# Heritage Formal Referral Response

|                                     | Application Information   |
|-------------------------------------|---|
| Referral Reference                  | IREF22/01352  |
| Address                             | 492 Queens Pde, Fitzroy North VIC 3068  |
| Proposal                            | Partial demolition, external alterations ground floor<br>extension to the existing hotel including outdoor partially<br>covered courtyard, increase in patron numbers (from<br>443 to 645) and modifications to the red line plan<br>(additional floor area to operate until 10pm in courtyard<br>area and 1am in enclosed areas), provision for live<br>acoustic music, installation of a promotion sign, deletion<br>of seven (7) car parking spaces (retention of two<br>spaces) and a reduction in the statutory car parking and<br>bicycle facilities rates. |

Figure 1: View of the Terminus Hotel, and existing painted sign, from Queens Parade (source: Google StreetView)

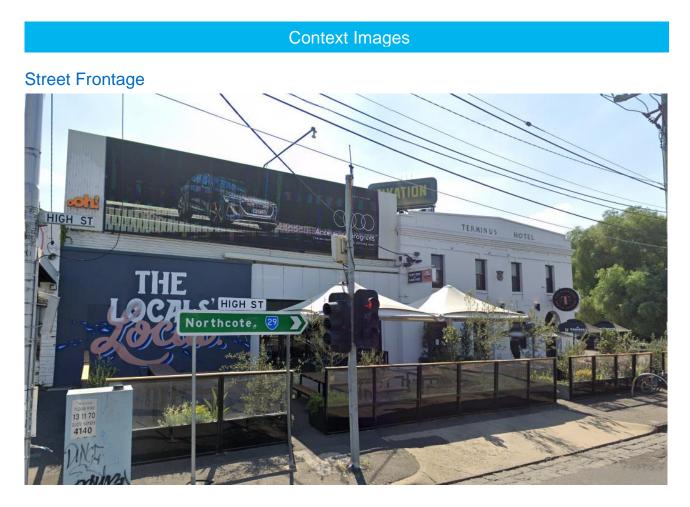
The proposed painted advertising sign, which is currently in situ, is visible from Queens Parade. The content and design of the sign is relatively simple and this ensures that it does not adversely impact the presentation of the original hotel building. The sign is acceptable in its current form, however a condition should be placed on any permit requiring any changes to the existing sign to be submitted to council for review and approval.

|    | Suggested Condition  | Explanation  |
|----|--|--|
| 1. | Require any changes to the proposed painted sign to be submitted to council for review and approval. | In its current form, the sign is acceptable,<br>however if the design were to change, there<br>could be an adverse impact on the broader |
